Ref: 10780.010
3 September 2018

**Southern Cross Hospital Expansion, Newtown
Transport Response to Section 92 Request for Further Information**

Southern Cross Hospital Ltd (“Southern Cross”) lodged an application for resource consent (SR 414740) to expand their current operation at 90 Hanson Street, Newtown. Wellington City Council has subsequently issued a Section 92 request for further information, of which a number of items relate to traffic and transport matters. A response to each of these is provided in turn below.

Southern Cross Hospital Expansion
Upper Level Parking Layout

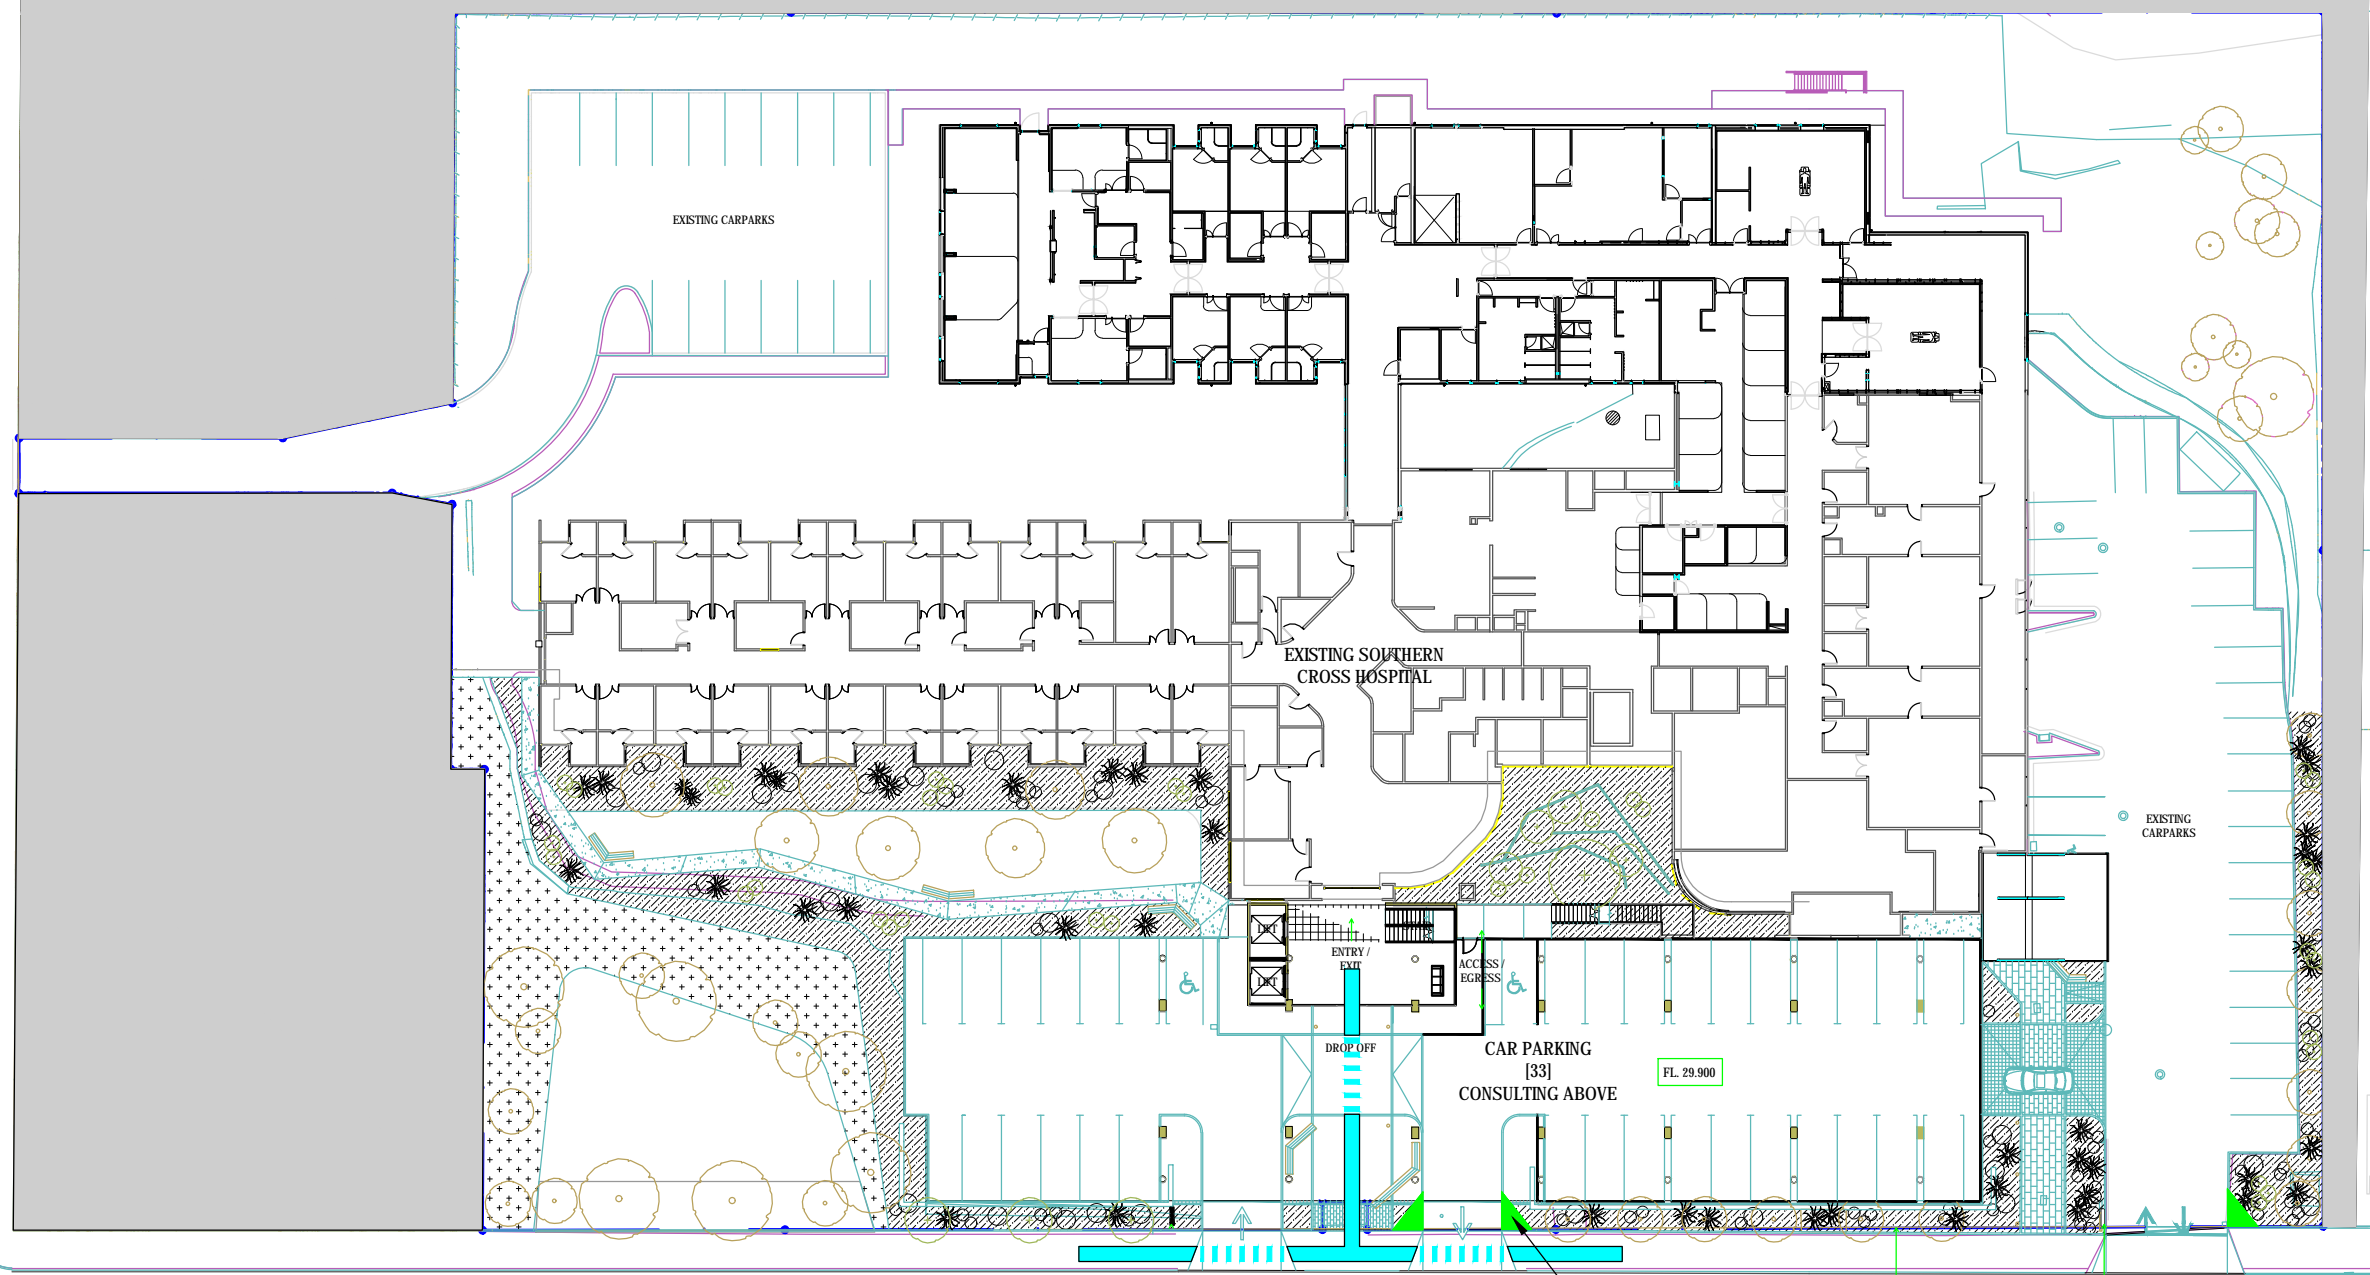
Show visibility splays at all the vehicle crossings and between the driveway and pedestrian paths within the site. The proposed internal pedestrian paths must be defined clearly with complying visibility splays.

The plans provided at **Appendix B** illustrate the pedestrian visibility splays around the site (as green triangles), which satisfy the requirement of AS/NZS 2890.1.

Pedestrian visibility splay provided in line with AS/NZS 2890.1
